### C. Second Response to Environment Agency

**RE: Stage Brewery – River Wall**

I am writing in response to your comments dated 18<sup>th</sup> September 2018 in relation to the proposals for a new river wall at the Stag Brewery Site (planning reference: 18/0547/FUL). Please see below the information in response to your comments.

## E. Updated Defence Drawings – Ship Lane

SECTION D D - EXISTING GROUND

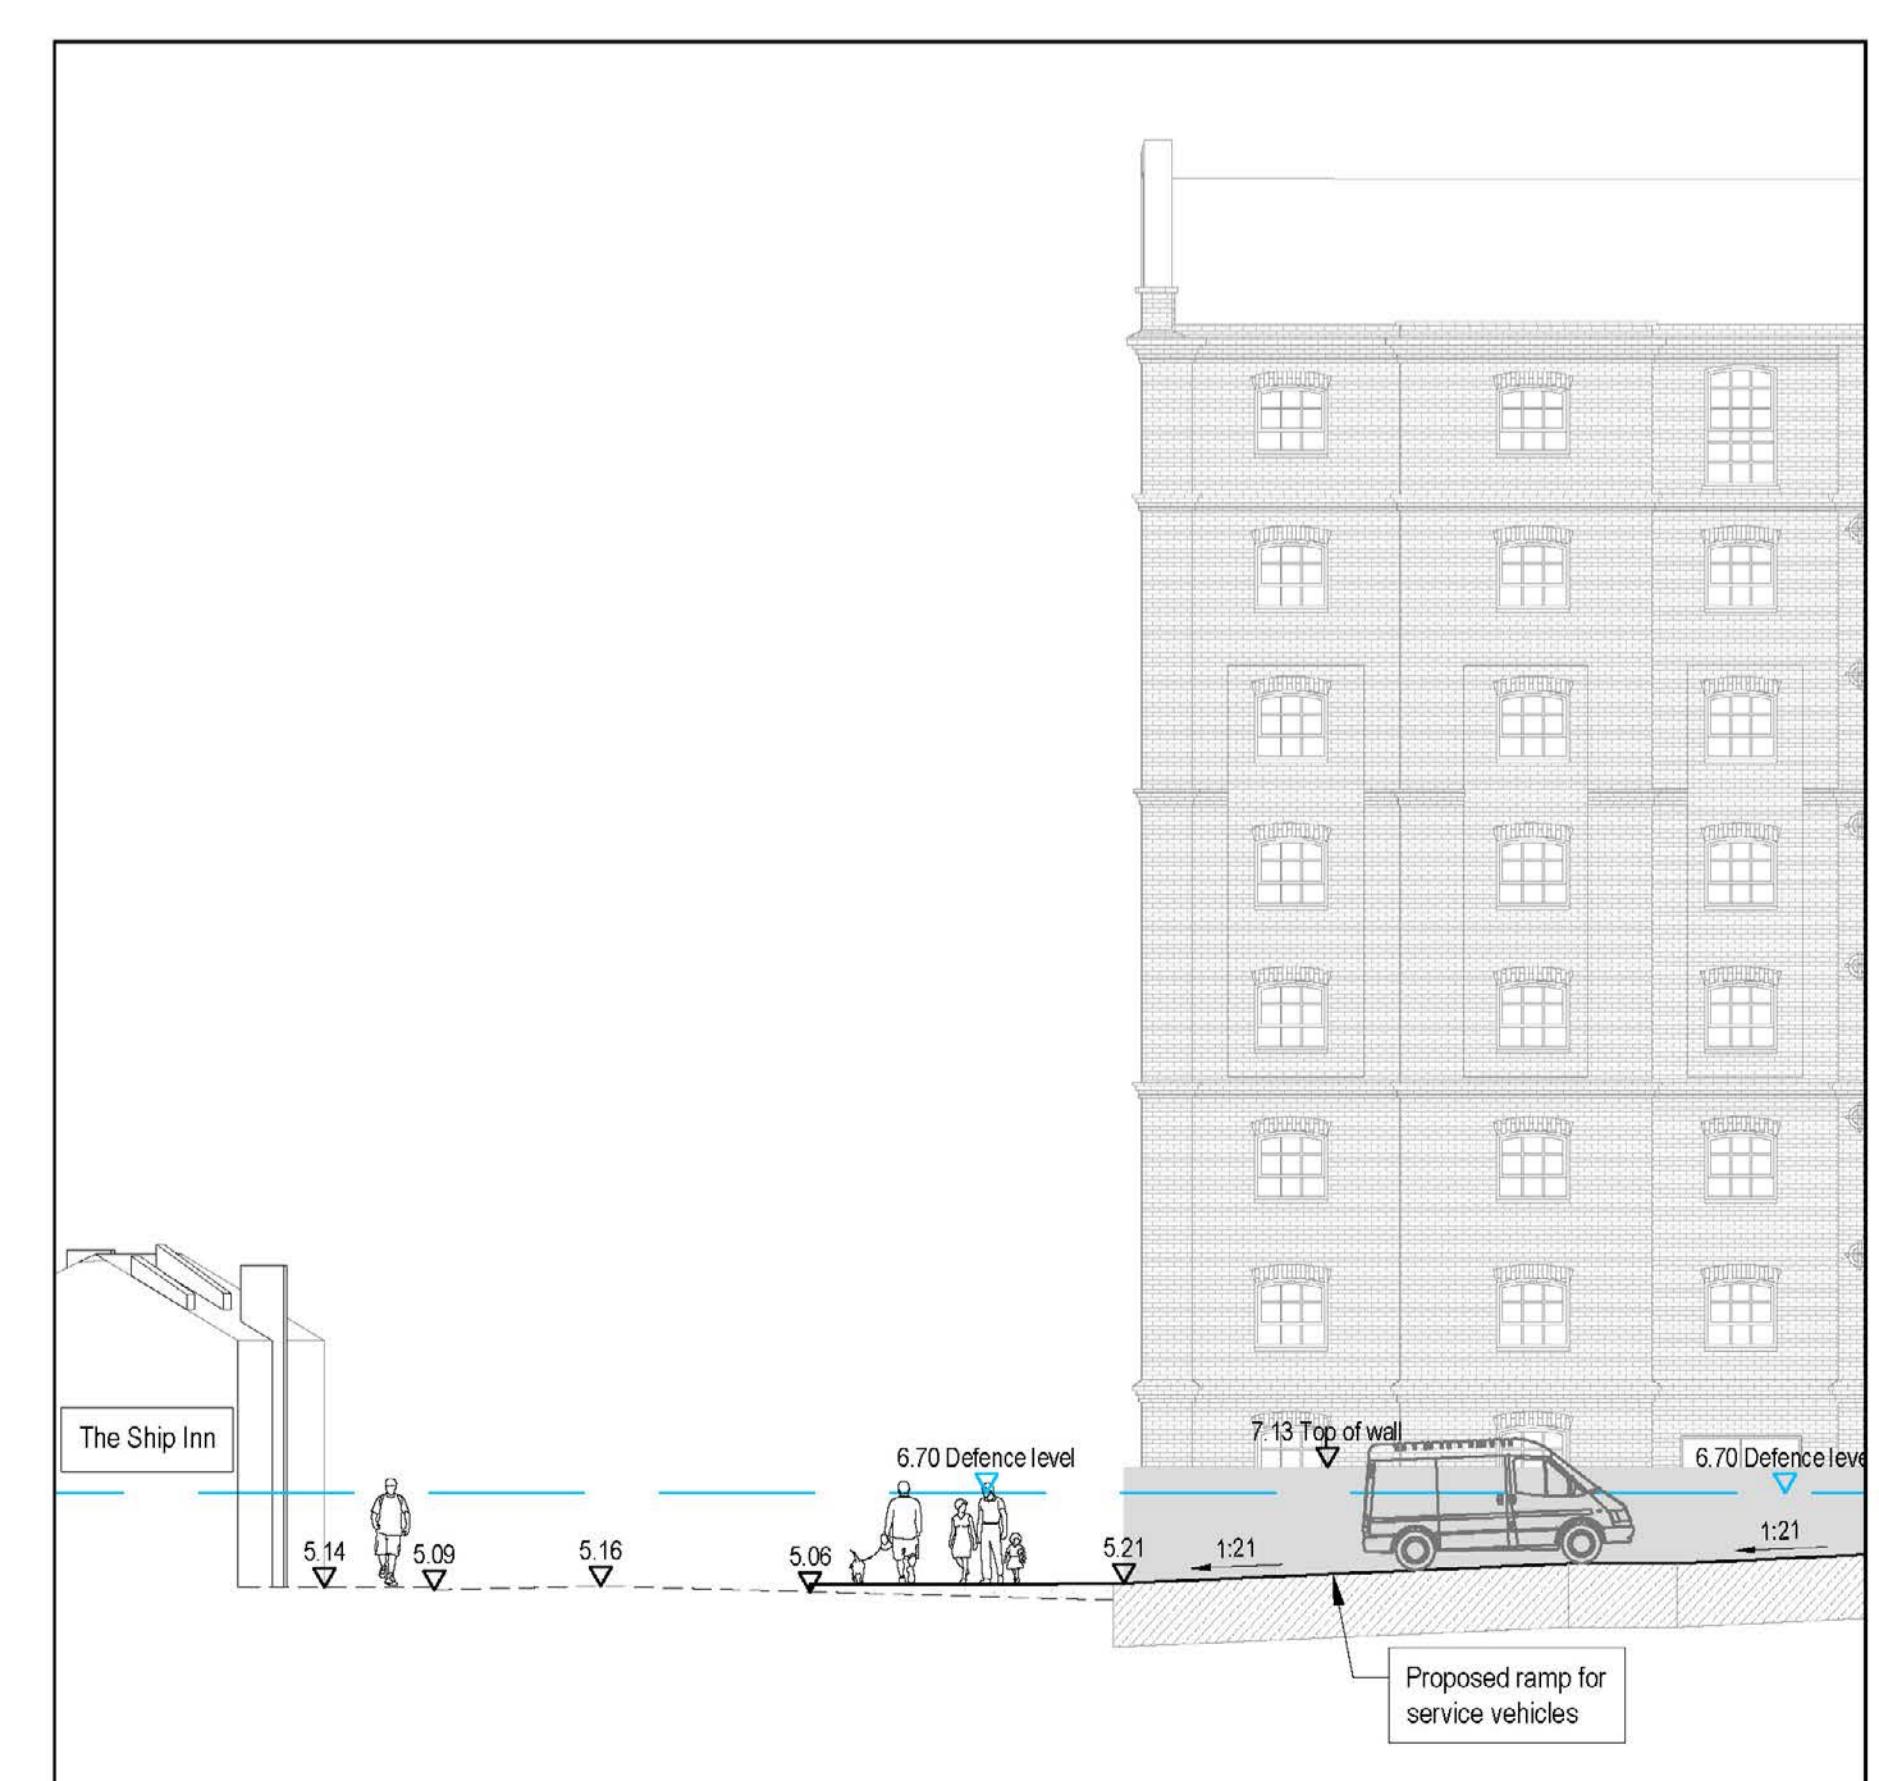
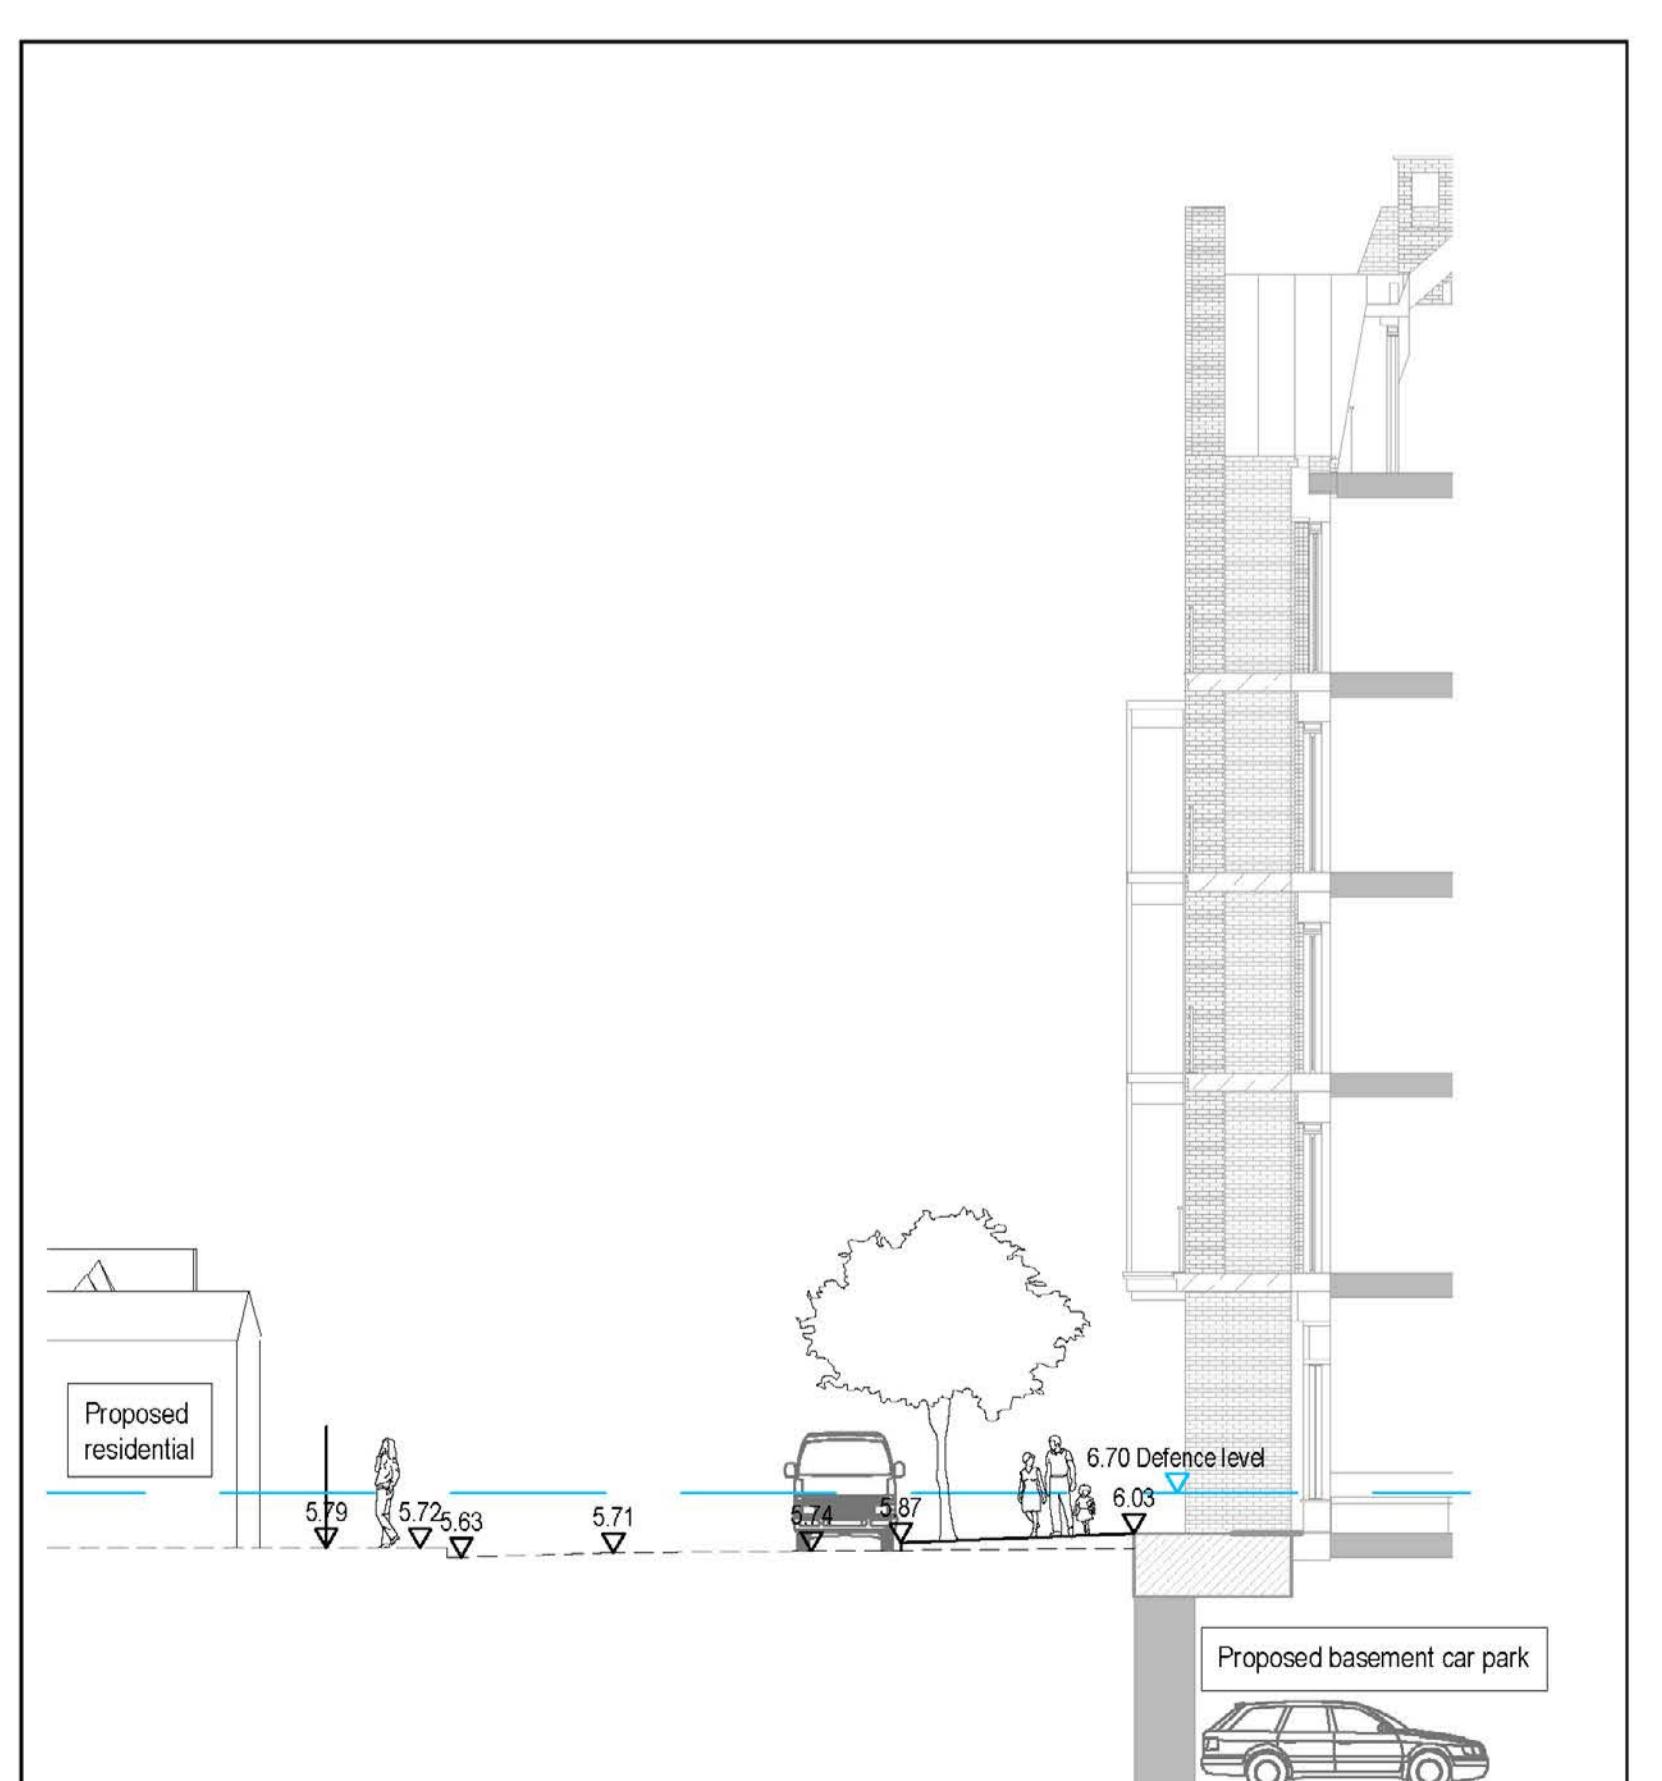
**Query 5) – Ship Lane and Bull Alley** – Bull Alley, and the flood boards for this location are within the redline boundary of the application. Irrespective of ownership, developer will have to demonstrate both the residual lifespan and TE2100 crest level raising for all tidal flood defences within their red-line boundary. Our preference would be for the flood boards to be removed and a passive (static) flood defence installed. Regarding Ship Lane, we appreciate the applicant may not be the freeholder of this land, and therefore may not be liable to ultimately provide the flood defence across the road. However, the applicant is responsible for demonstrating how all flood defence line within their redline boundary, will be treated in light of TE2100 raising requirements and how these will tie in with the

We appreciate that a passive defence is always preferable, however the practicalities of raising Ship Lane itself mean that this option is not suitable. It is correct that the level of Ship Lane does rise to circa 6.1m AOD and that at this point a raise of only 600mm would be required. However, this would result in the River Thames Defence line moving back along Ship Lane in a southerly direction which in turn will allow flood water to flow further down Ship Lane than it would currently do. As a result, the defence height of 6.7m AOD would then need to be in place on either side of Ship Lane. This would render the currently proposed active frontages along Ship Lane unfeasible and would create a narrow corridor with walls on either side.

If constraints mean that passive defences are not possible to the full TE2100 height of 6.7m AOD then the EA would want the height of any gate limited to minimum it needs to be (i.e. raised ground provides protection to say 6.0m AOD and then a gate would only need to be 0.7m high).
